# OUTLOOK POWERS & GRINNELL FILING NO. 1 FINAL PLAT

## LETTER OF INTENT

**MAY 2023**

### Access

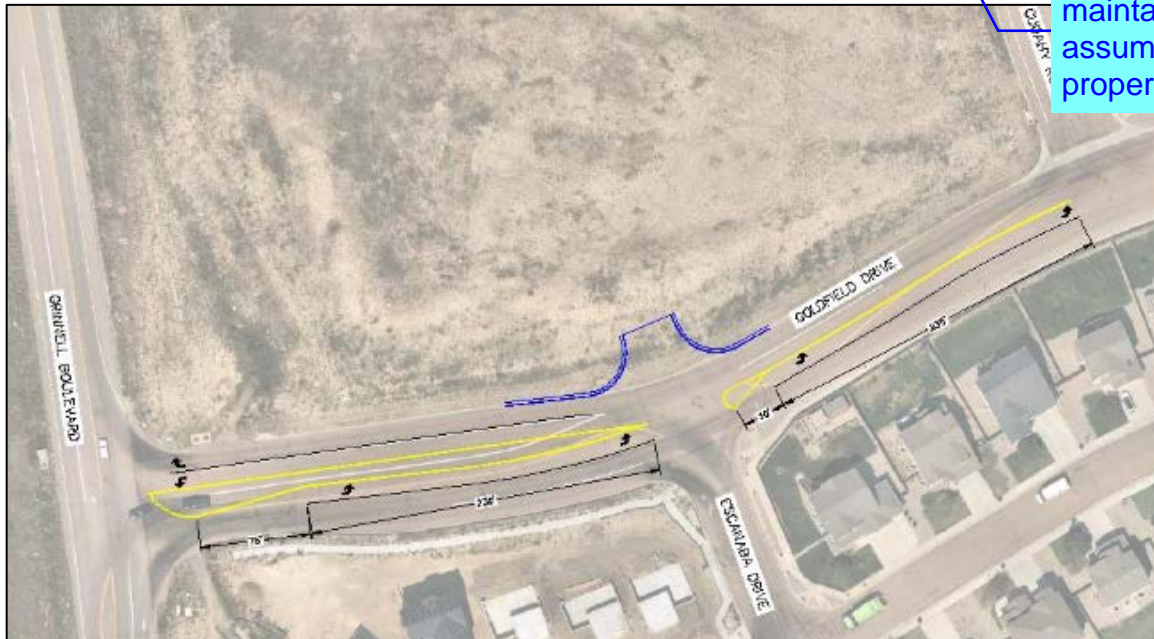
Deviation requests were not submitted with this final plat application. Please submit deviation requests.
